COMMONWEALTH OF KENTUCKY  
BEFORE THE KENTUCKY STATE BOARD ON ELECTRIC  
GENERATION AND TRANSMISSION SITING

<i>Electronic</i> Application of Golden Solar, LLC	)	
for Certificate of Construction for an	)	
Approximately 100 Megawatt Merchant	)	Case No.
Electric Solar Generating Facility in Golden	)	2020-00243
County, Kentucky	)

**Response to Siting Board Staff's Post-Hearing Request for Information**

Figure No.  
**ESB-03-4-1**

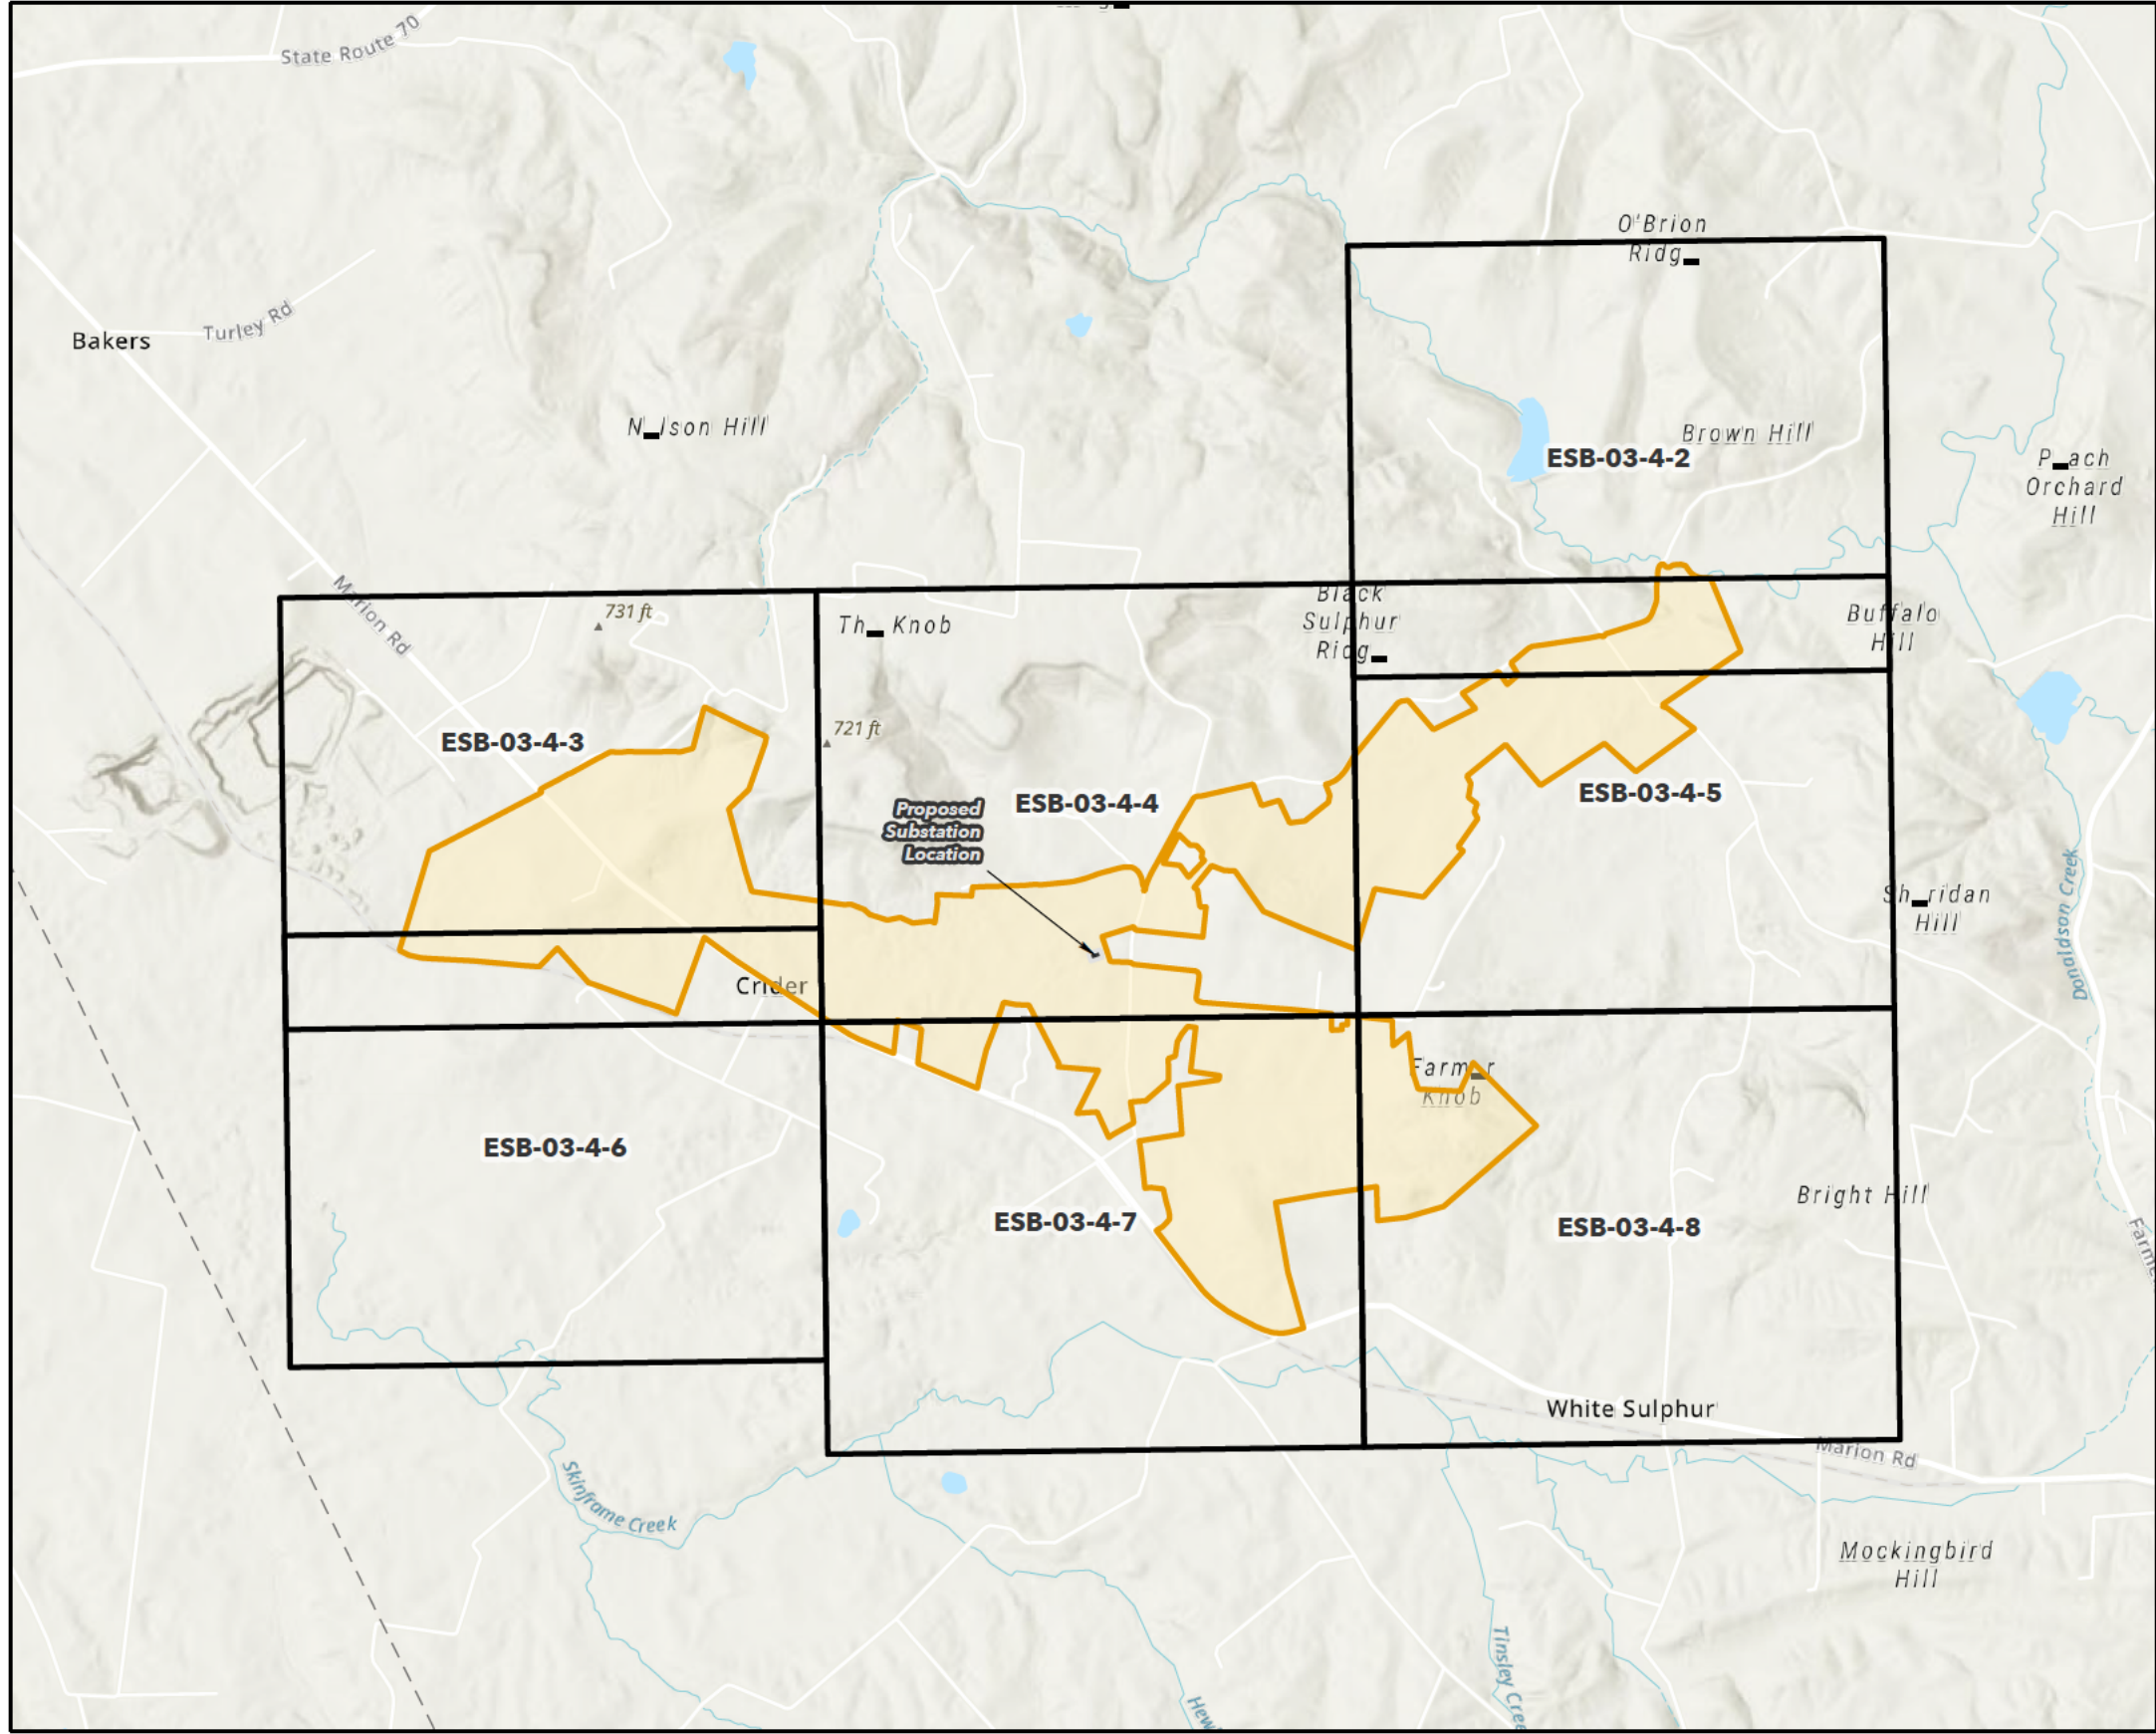
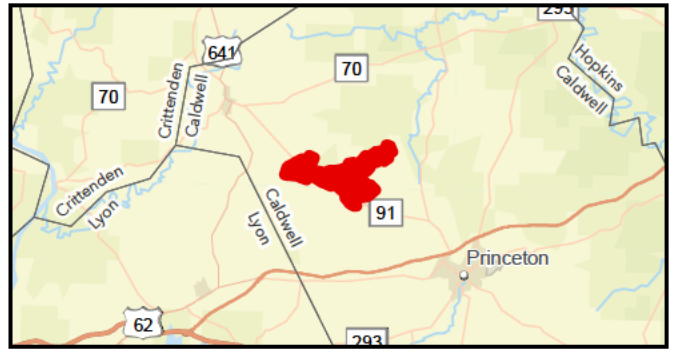
4. Provide a chart with the distance between non-participating residences and the solar panels, the inverters, and project substation.
-

A table with distances from non-participating and participating residences to solar panels, inverters, and the project substation based on the preliminary design is attached hereto. The exact distances between project equipment and residences are subject to change with final design; however, Golden commits to placing panels no closer than 200 feet from residences, inverters no closer than 450 feet from residences, and the substation no closer than 1,000 feet from residences, unless the setback is waived by a landowner.<sup>1</sup> Additionally, Golden has requested a deviation from statutorily required setbacks for the residential neighborhood of 1000 feet for the substation, 500 feet for any central inverter, and 300 feet for any panel.<sup>2</sup>

**Traffic Study Figure**

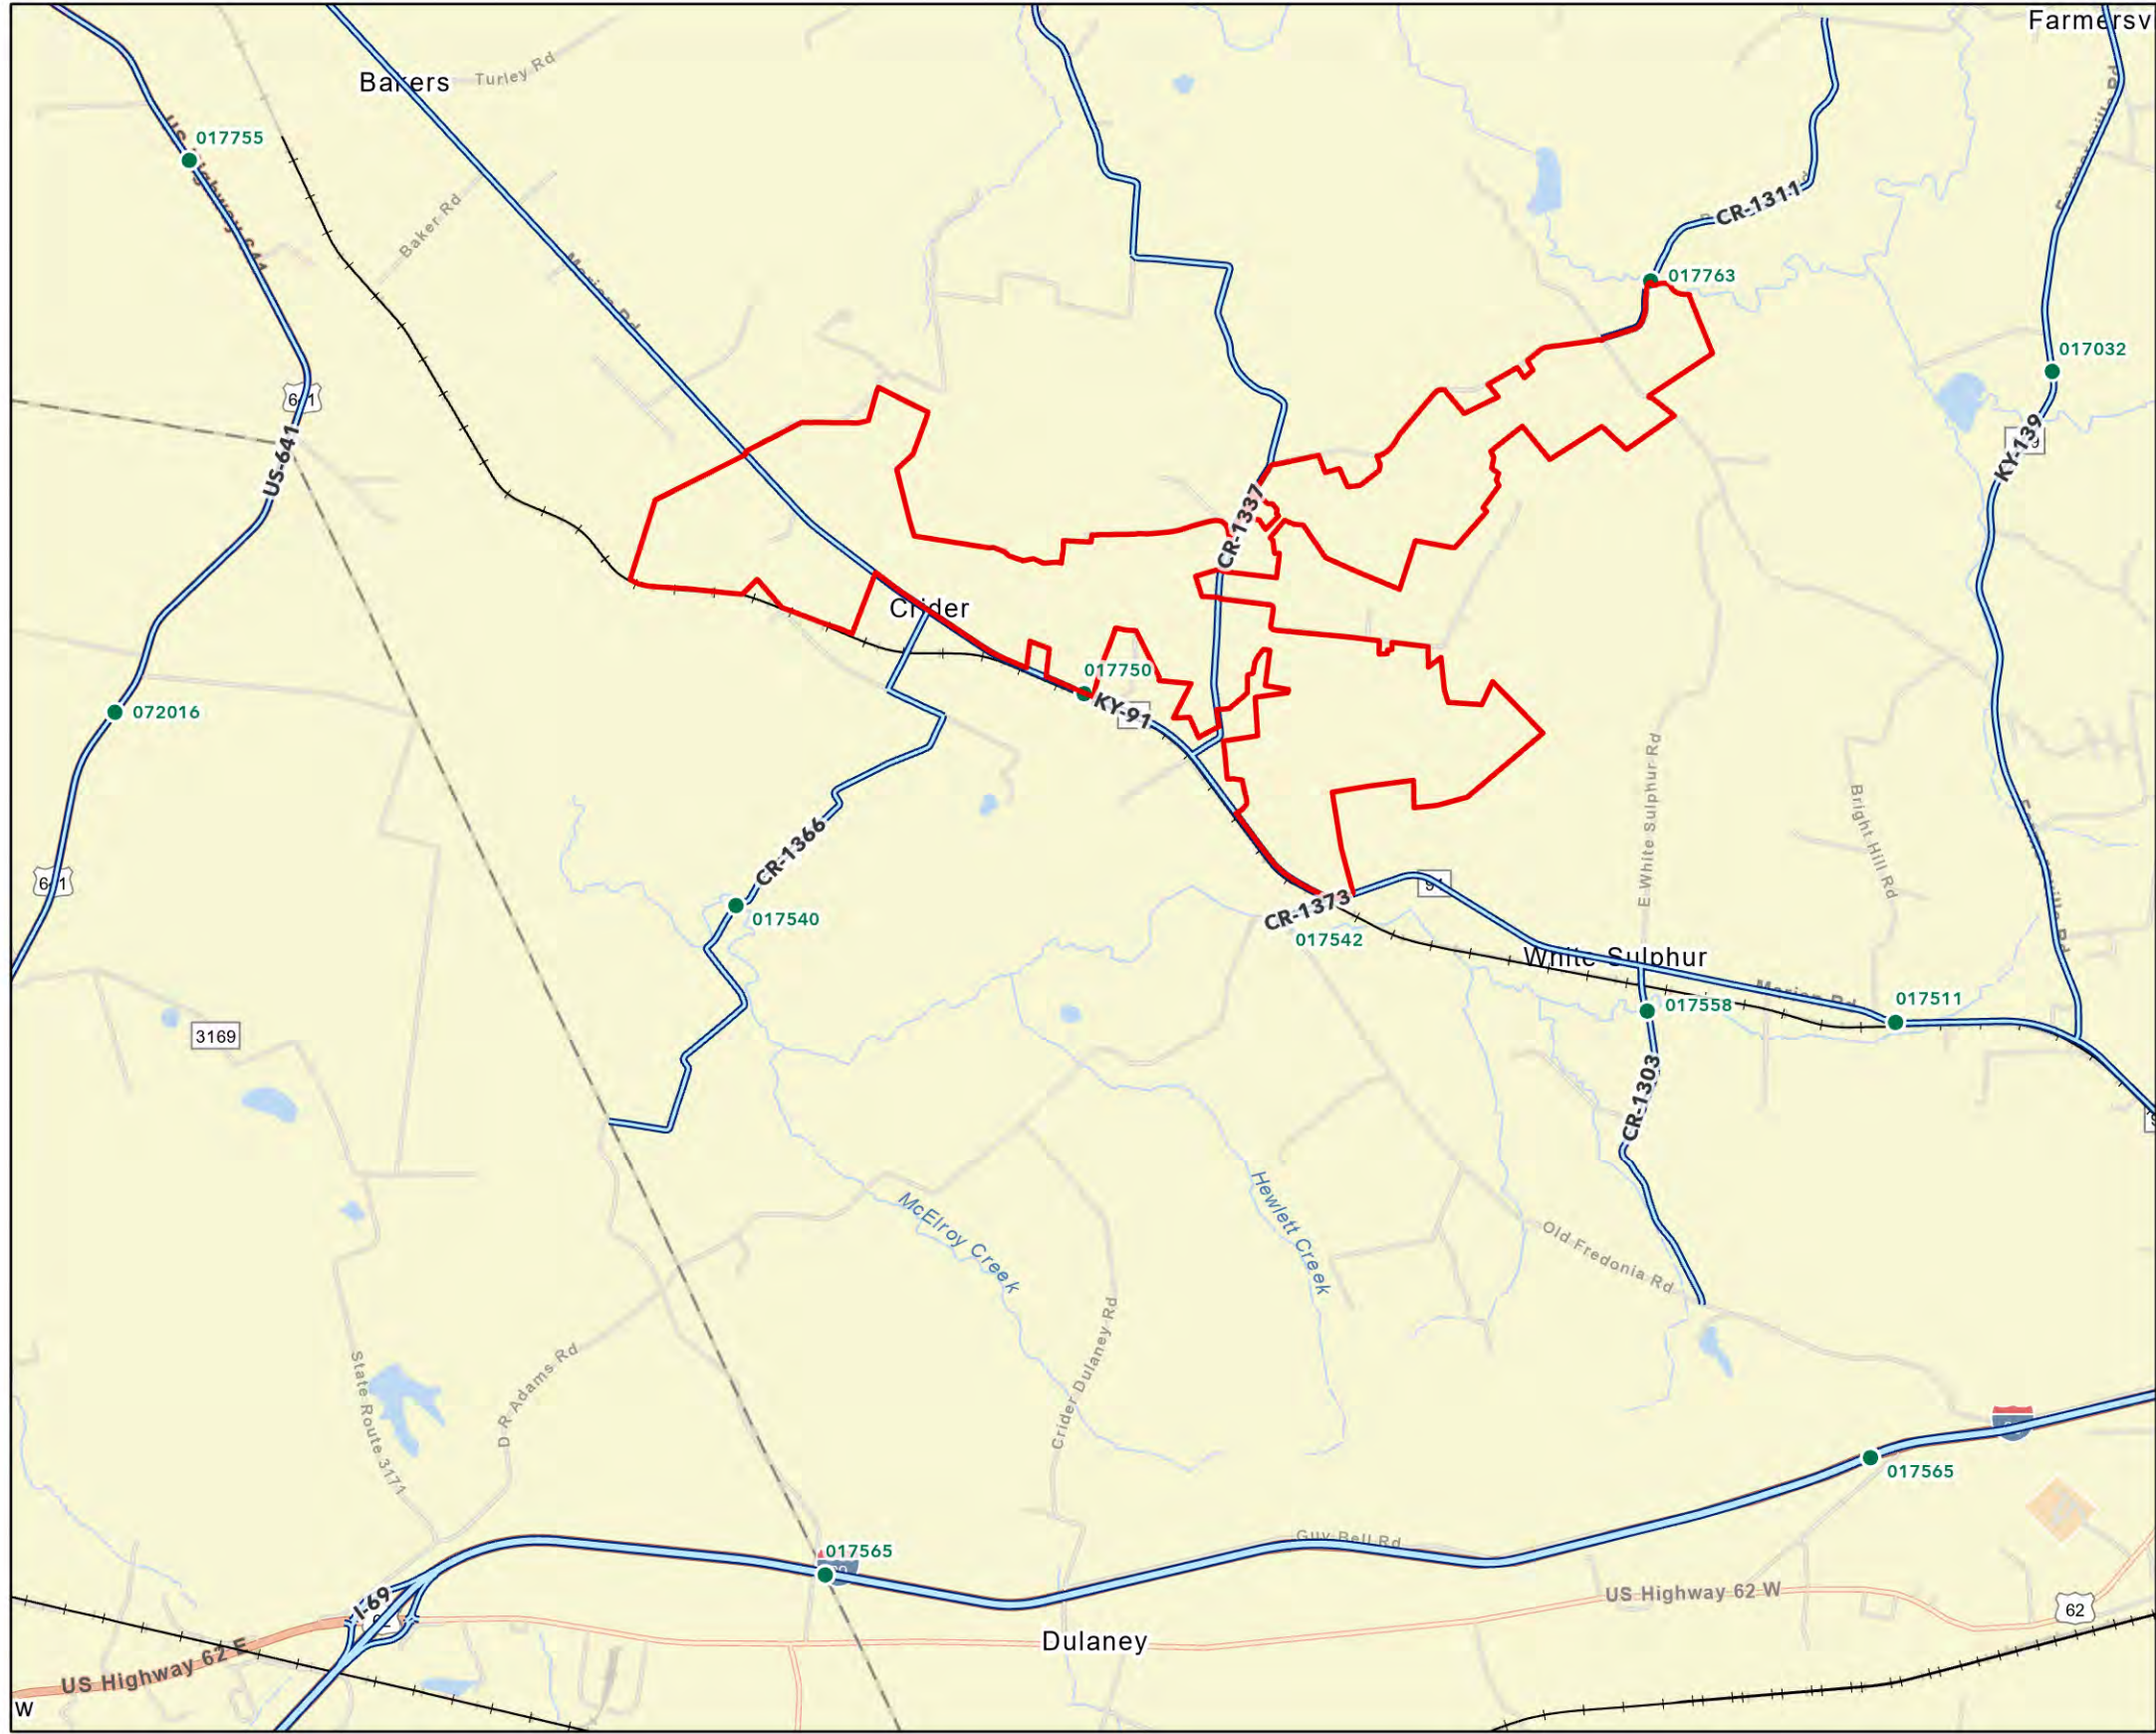
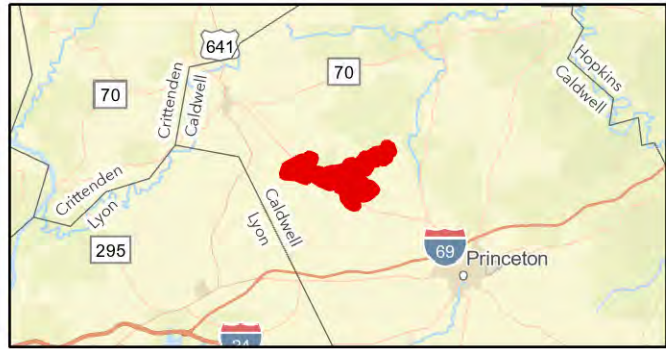
5. Provide Golden Solar's traffic management plan for construction and deliveries going to the site that will avoid negative impacts on the community, specifically the school zone on Marion Road.
-

A traffic management plan is attached hereto. Golden Solar representatives spoke to the Superintendent of Caldwell County Schools, Jeremy Roach, on January 20<sup>th</sup> about the Golden and Caldwell solar projects. Golden Solar representatives provided Mr. Roach with details about expected traffic and transportation routes during construction of the solar projects and Mr. Roach provided details about typical peak school drop-off and pick-up times and associated traffic. Golden Solar will incorporate consideration of peak school traffic schedules when preparing construction traffic and delivery plans and will minimize or mitigate impacts on school traffic to the extent feasible. Proposed mitigation measures for the school zone on KY-91 are discussed in the attached traffic control plan.

- Scheduling of oversized delivery trips (i.e. main power transformers) within the school zone outside of peak school drop-off and pick-up times. These delivery trips can also be scheduled for periods such as holidays and/or spring/summer/winter breaks.
- Communicating general construction schedules with the superintendent of Caldwell County Schools.
- Designing traffic control procedures to maximize driver and pedestrian safety as these delivery trips are traveling along KY-91 within the school zone. These procedures will be coordinated between the Owner/Contractor and state/local officials as the design and construction schedule of the Golden Solar Facility develops. The Owner/Contractor intends to comply with applicable Work Zone Traffic Control standards set forth by the Manual on Uniform Traffic Control Devices and by state/local agencies.
